Humanetics Innovative Solutions, Inc.

BioRID II Head/Neck Storage and Lifting Enhancement Kit

BioRID II Head/Neck Storage and Lifting Enhancement Kit

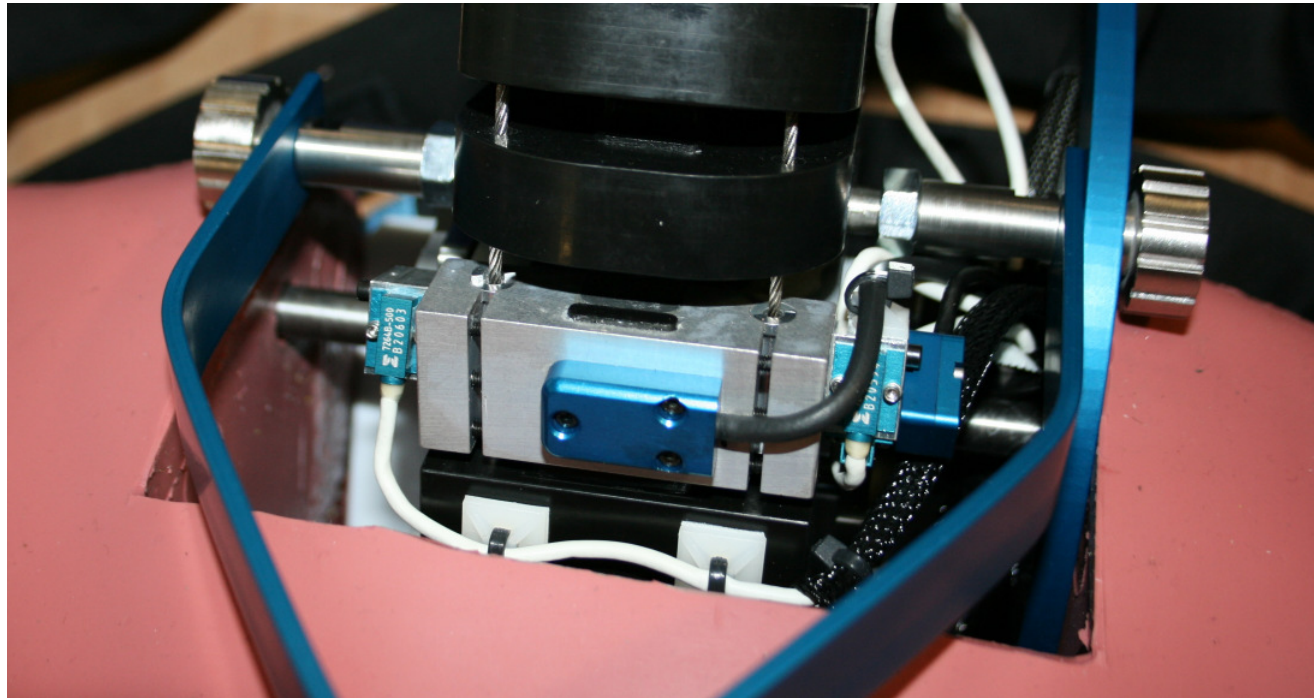
The head locking bracket as well as the neck lifting bracket are used on the BioRID II ATD. With the addition of angular rate sensors and the upgrade of BioRID dummies to an in-dummy DAS system, there is a need to increase the Space around the T1 accelerometer locations left and right.

Humanetics Europe has developed side extension pieces for the T1 axis along with Special bolts for the attachment of the head locking bracket and neck lifting bracket. In addition, the locking bracket gets a new head attachment plate with an increased slot length for more flexibility. A minor modification to the tool is required due to the umbilical inside the ATD.
